CITY OF SUNNYVALE REPORT ZONING ADMINISTRATOR HEARING

File Number: 2010-7890 **Permit Type:** Use Permit and Variance

Location: 921 E. Arques Ave (near De Guigne Dr.) (APN: 205-26-016)

Project Description: To allow new 12,000 sq. ft. multi-tenant shopping center on a portion of the property.

EAST ELEVATION

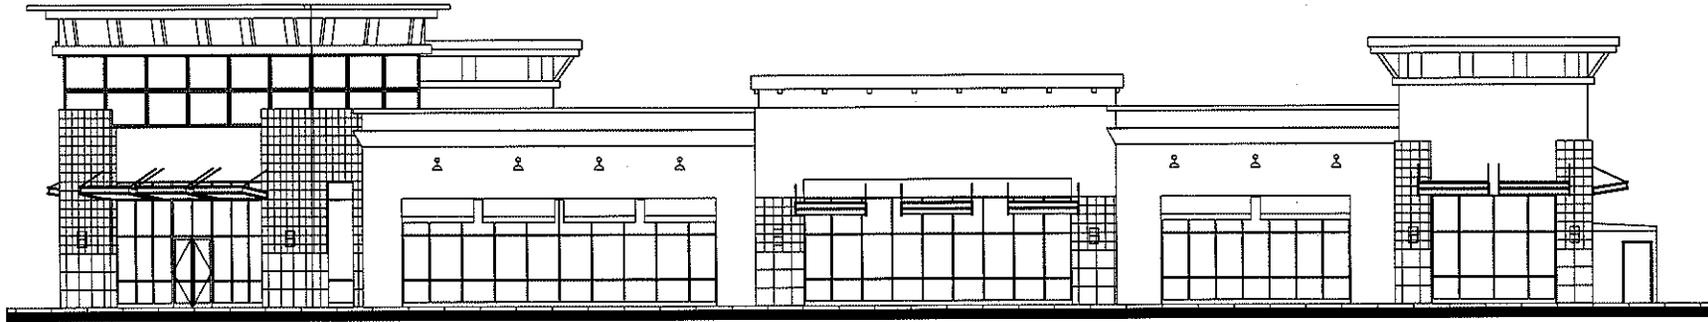
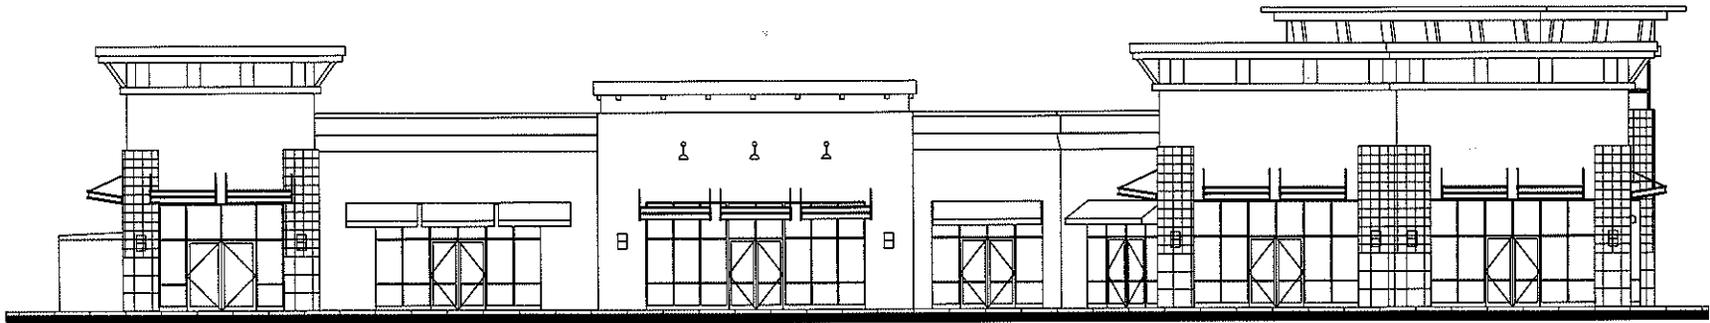
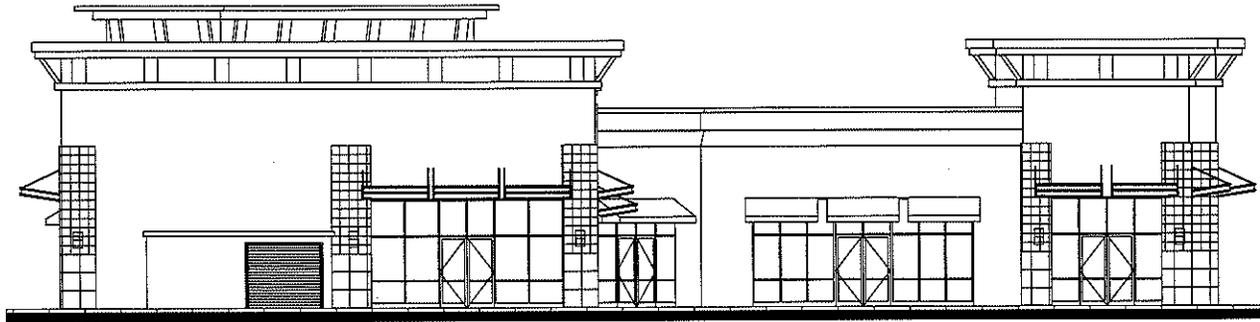
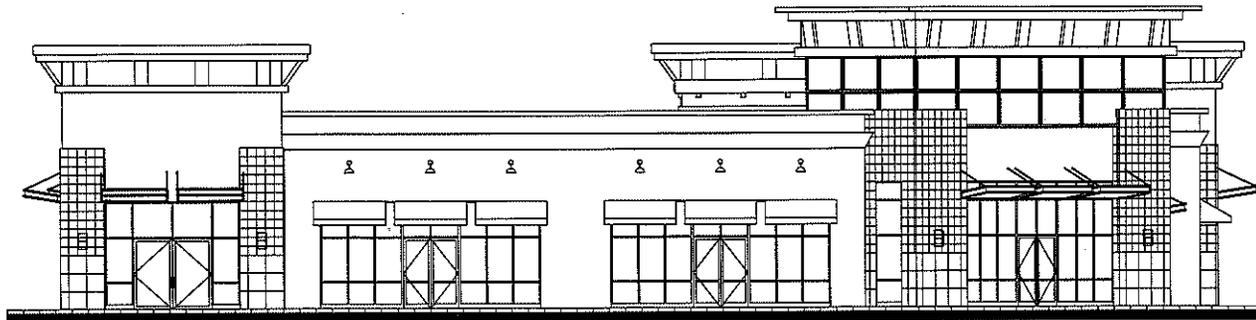
Architecture: Staff and the architect have extensively discussed the proposed architecture, including a site visit to a similar project. See architectural elevations in Attachment C for details. In general, staff is satisfied with the proposed architecture but is recommending some conditions of approval for greater detail. The conditions are as follows:

- a) The roofline cornices (tops) shall overlap one-another so they break-up the appearance of separate buildings.

- a) There shall be richer materials added to the pedestrian level (first 8'). This material needs to be carried up to the top in additional areas of the elevation.
- b) Wall lights shall be detailed further. This may include gooseneck lights for lighting the future tenant signage.
- c) Parking lot light standards shall be revised to a better luminaire.

- a) There shall be richer materials added to the pedestrian level (first 8'). This material needs to be carried up to the top in additional areas of the elevation.
- b) Wall lights shall be detailed further. This may included gooseneck lights for lighting the future tenant signage.
- c) Parking lot light standards shall be revised to a better luminaire.
